Urban Design Assessment: Park Apartments Phase 2

Applicant drawings dated 01-24-23

Prepared by: Brian Peterson, AIA, Urban Designer, T.O.C.H.
02-22-23

Diagram 2

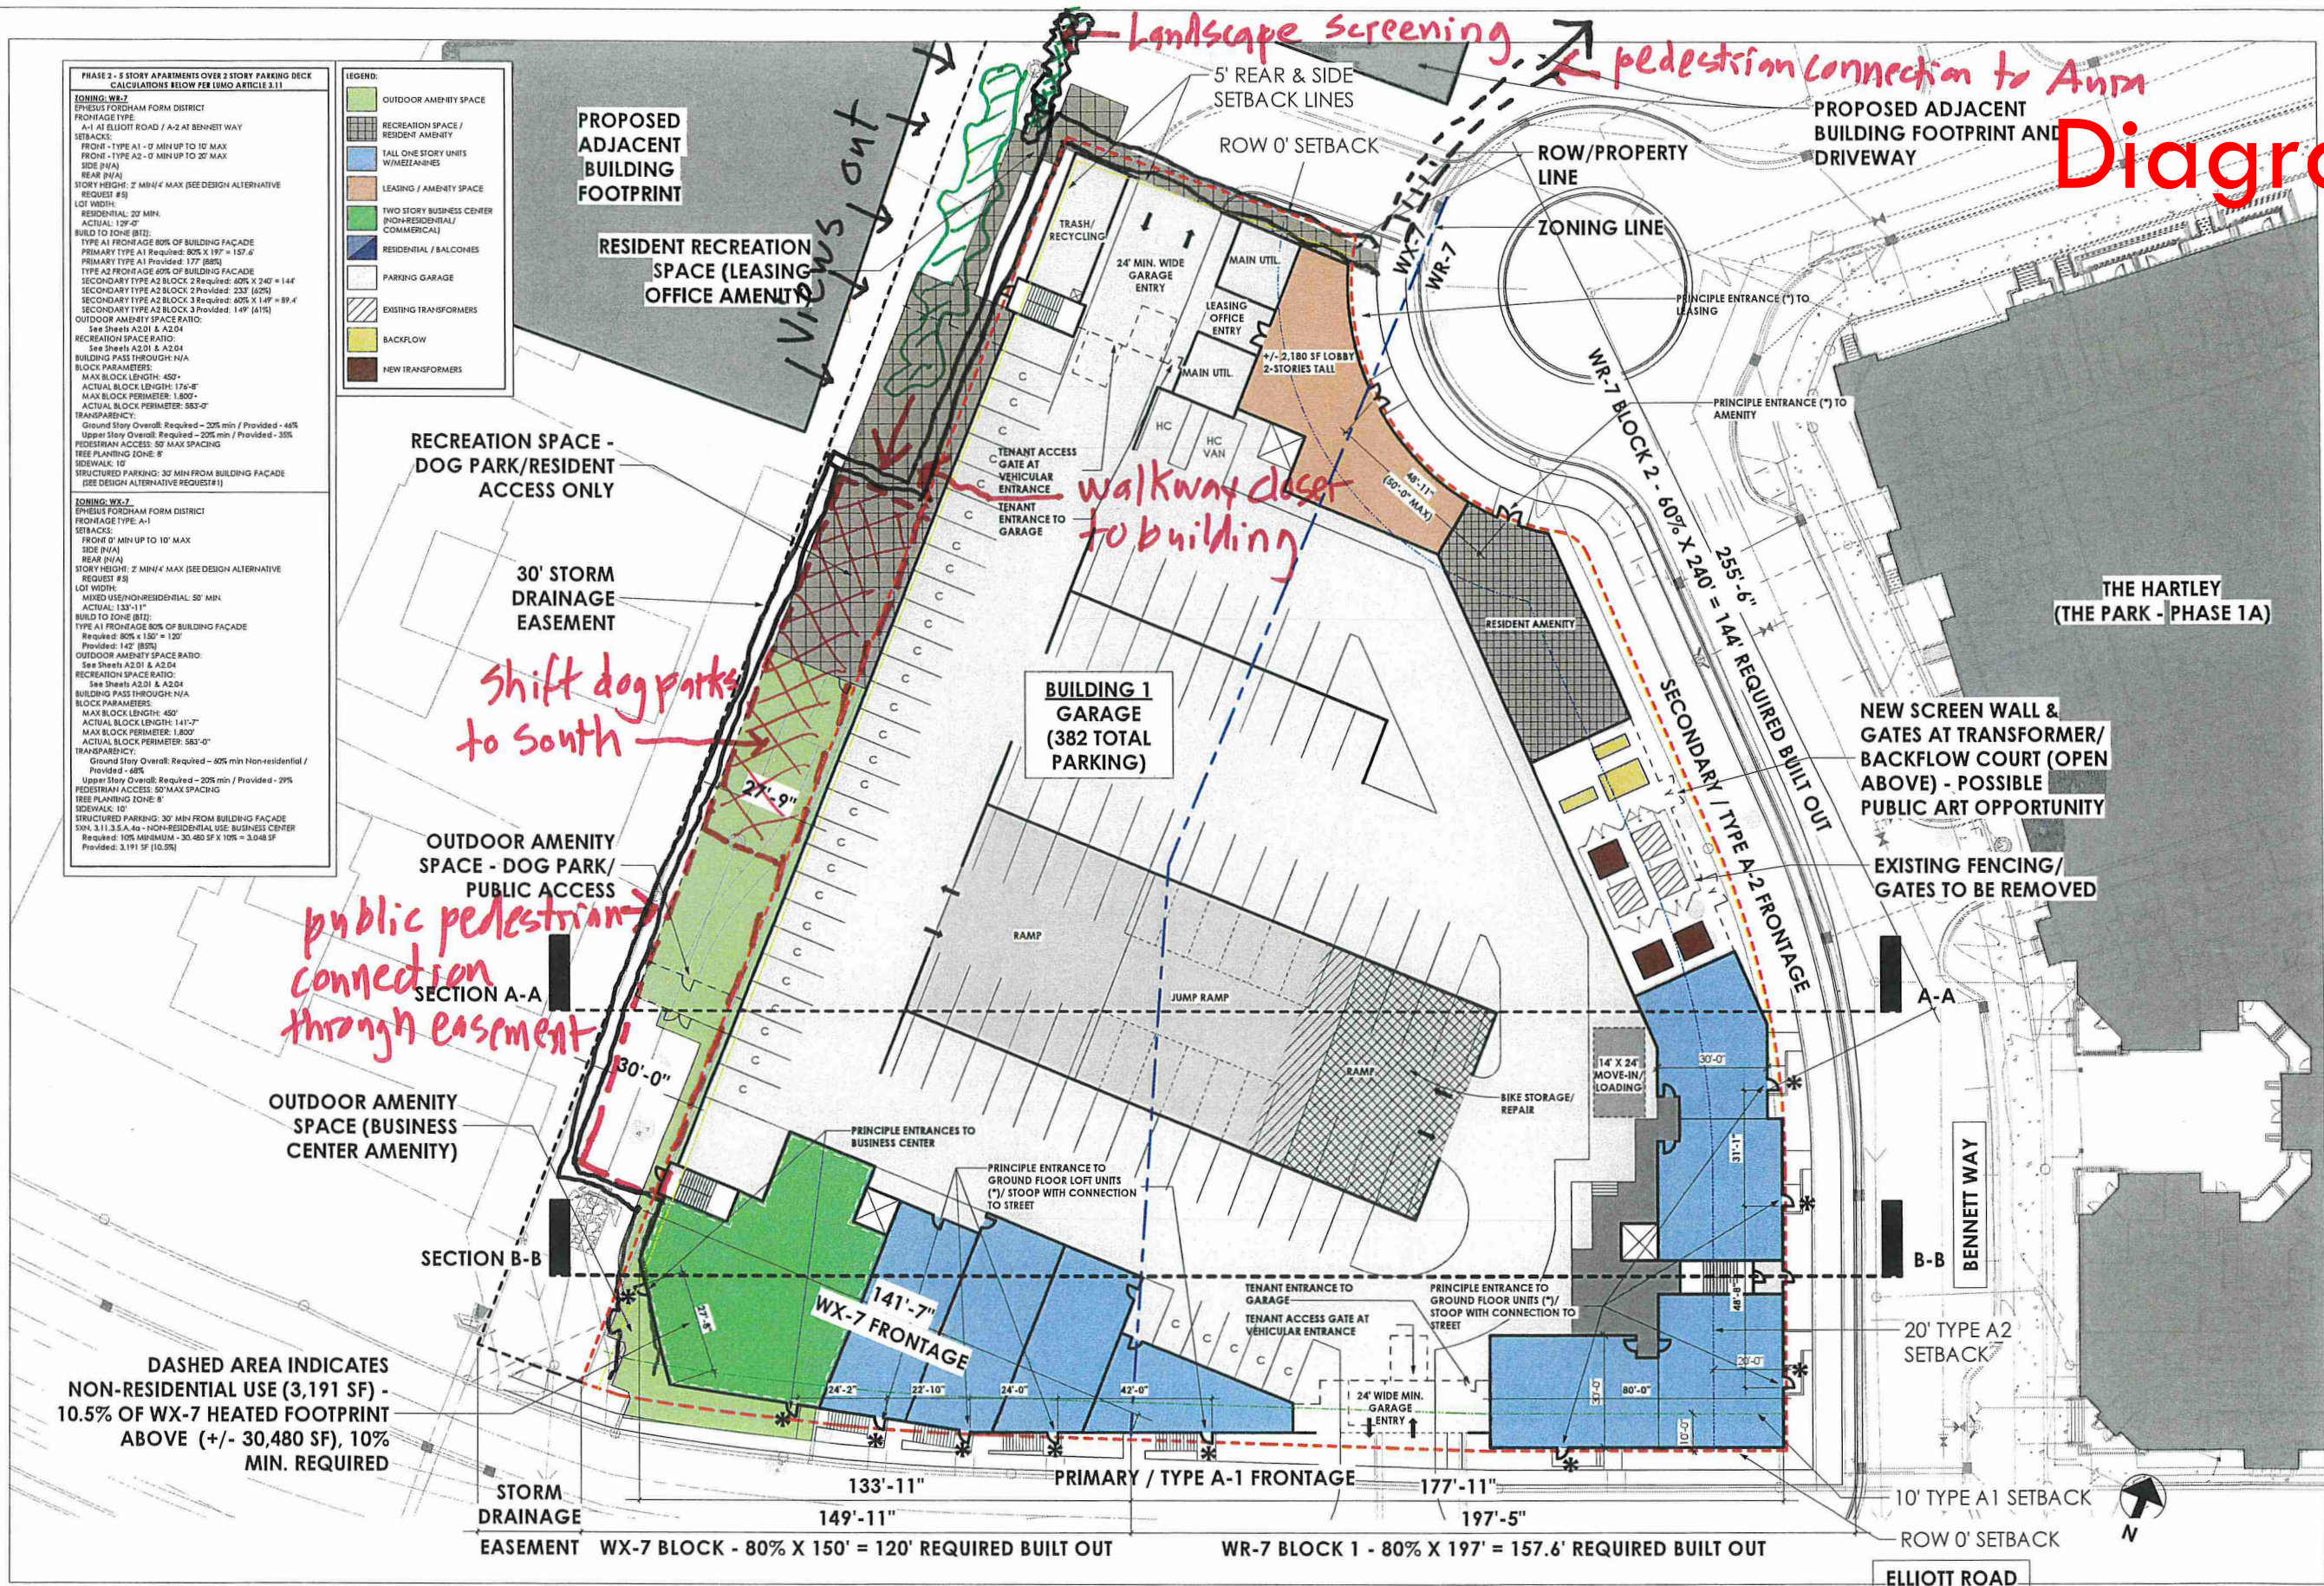
10. On the west elevation, where the parking levels are exposed, suggest using architectural screening rather than louvers. Consider an “art mural” (like what is being proposed on the Aura parking structure) or other enhancements especially along the ground floor level, which could provide a more interesting backdrop to the dog park spaces (see attached diagram 2). *(Applicant will consider these ideas.)*

screening other than louvers -
art on ground floor - see Aura
